# Preliminary thinking on magnet design: Italy

Andrea Bersani  
on behalf of INFN Genova magnet group

# FNAL proposed magnet

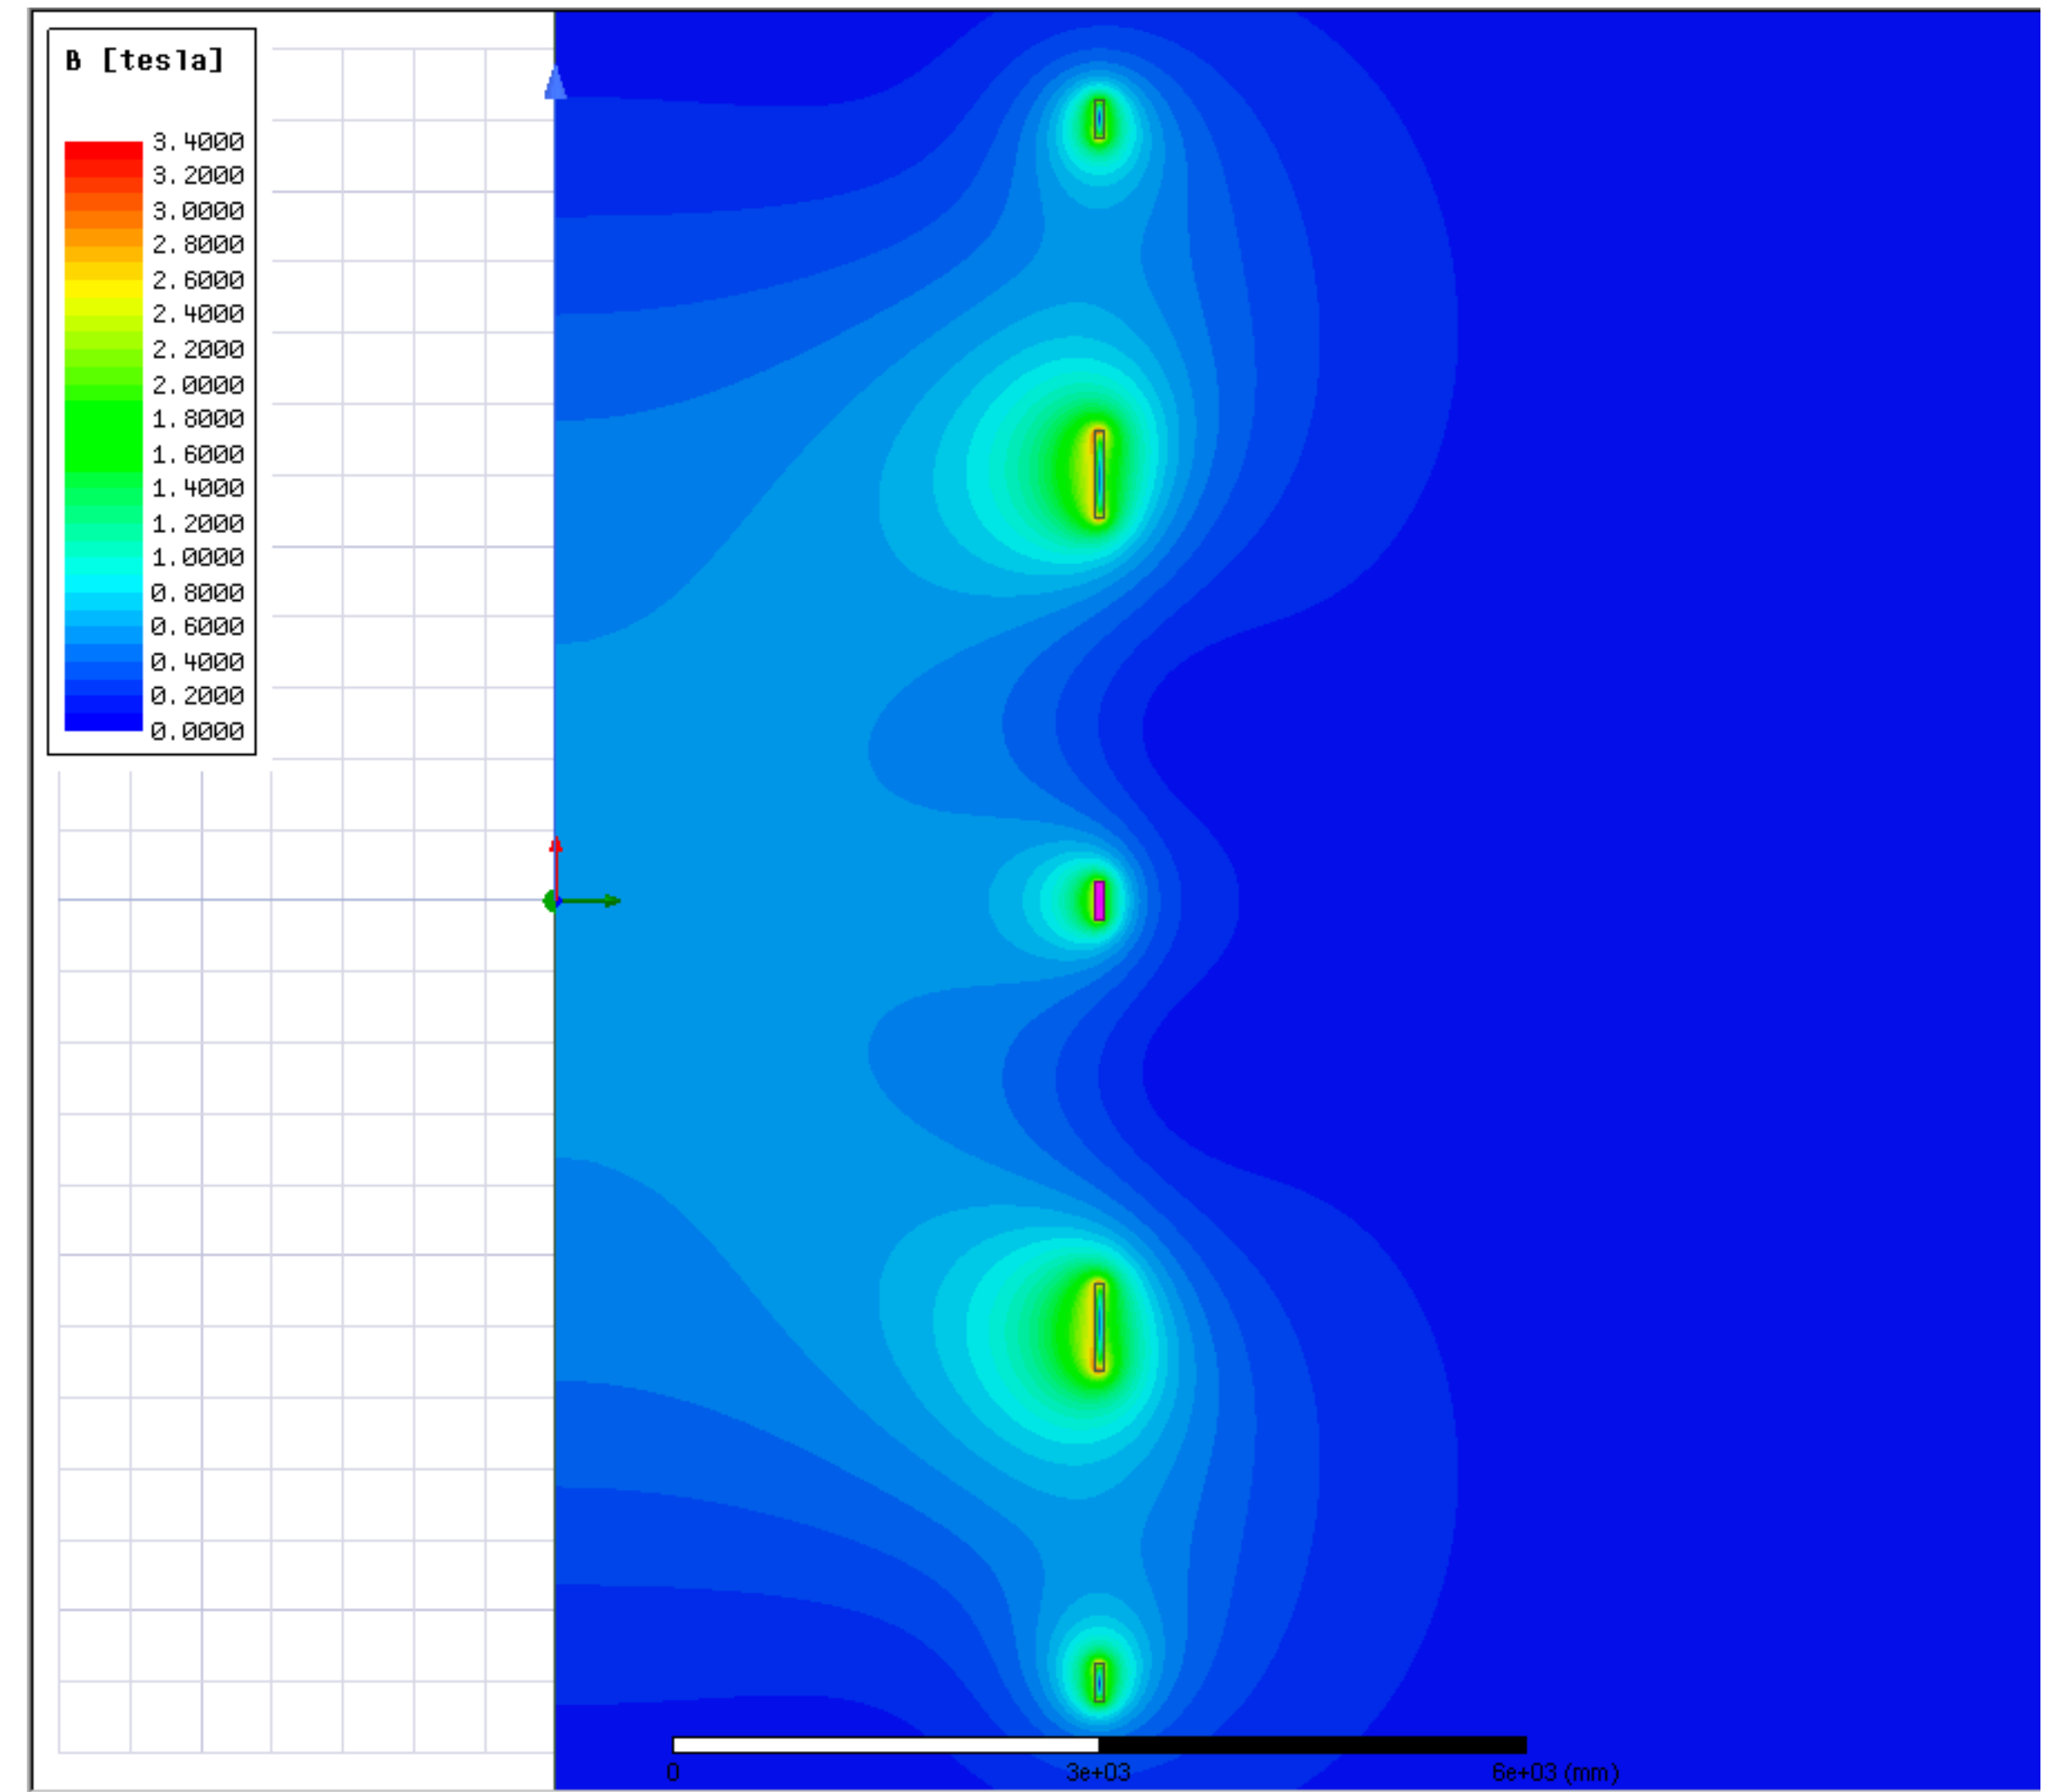
- ↪ Brilliant design with no iron
- ↪ According to our model:
  - ↪ overall current density:  $65 \text{ A/mm}^2$
  - ↪ stray field is non negligible
  - ↪ peak field on the conductor is  $3.4 \text{ T}$
  - ↪ total inductance is  $2.6 \text{ H}$
- ↪ With a  $0.1 \Omega$  dump resistor
  - ↪ max quench voltage:  $1000 \text{ V}$
  - ↪ max estimated temperature:  $\sim 300 \text{ K}$  (conservative)

# Lower current density

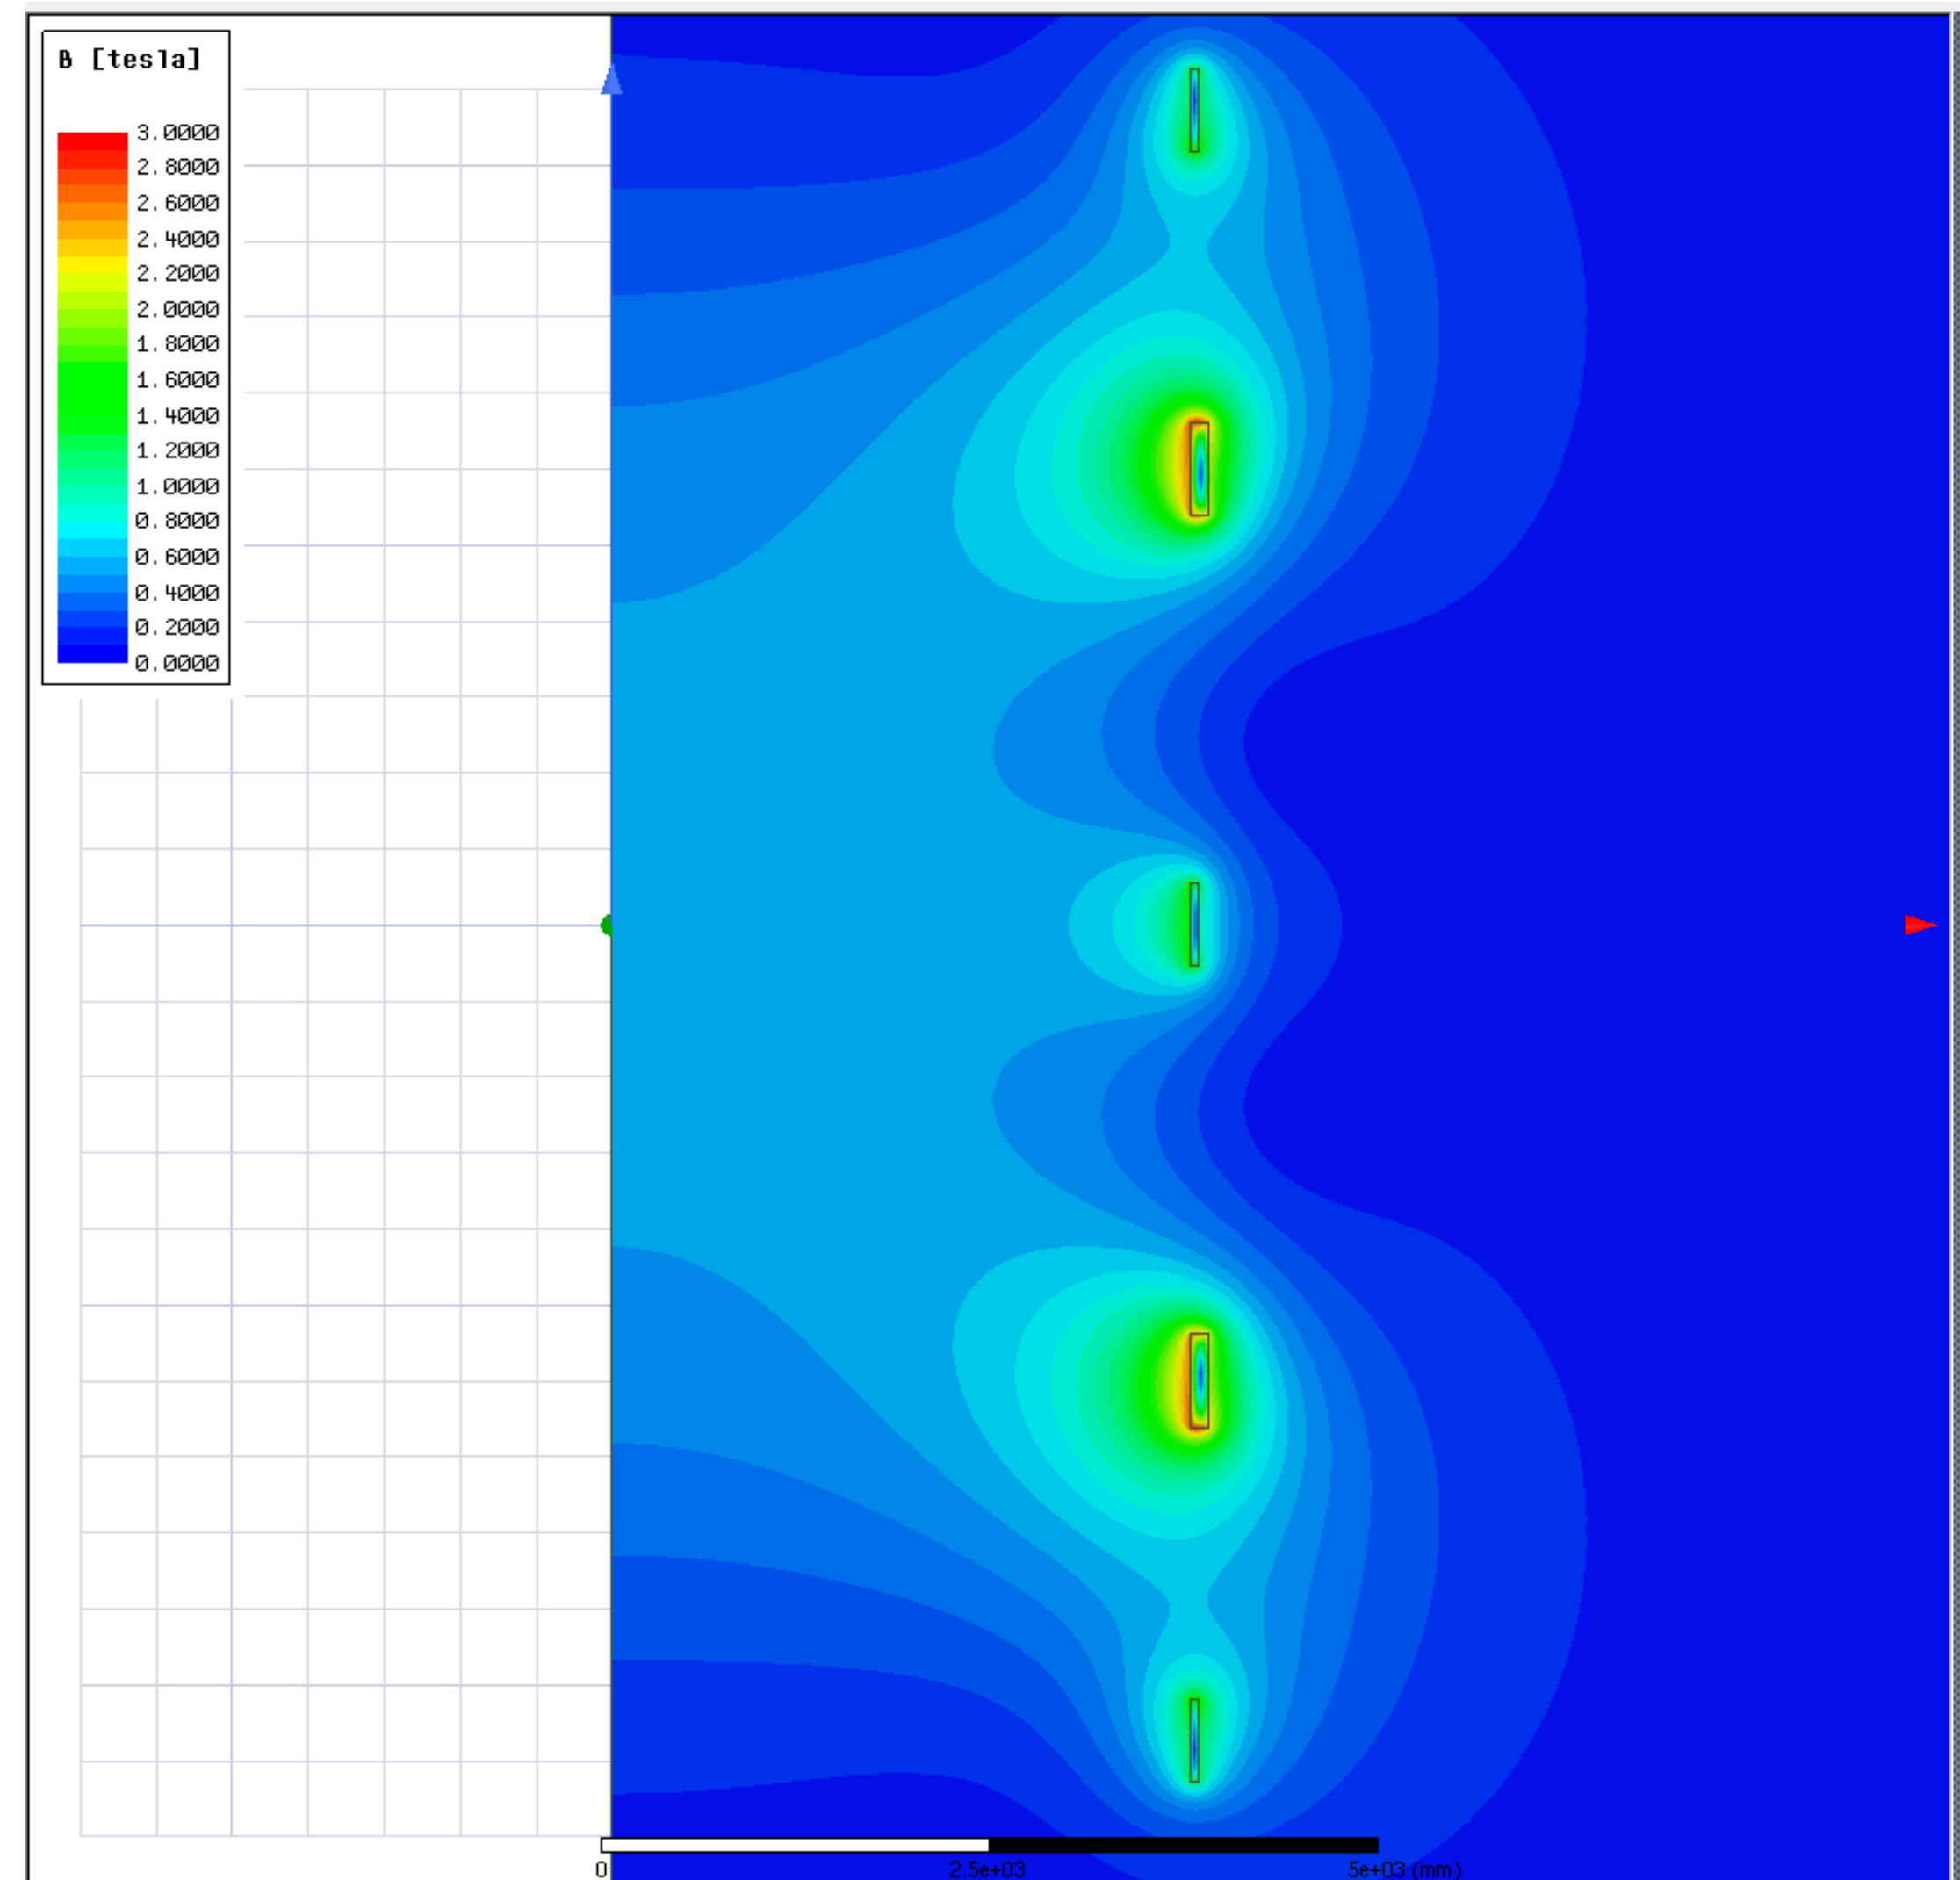
- ↪ A first option is to decrease the current density enlarging the coils
- ↪ Here we show  $33.5 \text{ A/mm}^2$ 
  - ↪ more uniform material budget
  - ↪ lower stray field (marginally)
  - ↪ lower peak field ( $3.4 \text{ T} \rightarrow 3 \text{ T}$ )
  - ↪ quench temperature  $< 100 \text{ K}$
- ↪ "More" cable needed
  - ↪ mainly stabilisation aluminium
  - ↪ perhaps  $< 5\%$  more length
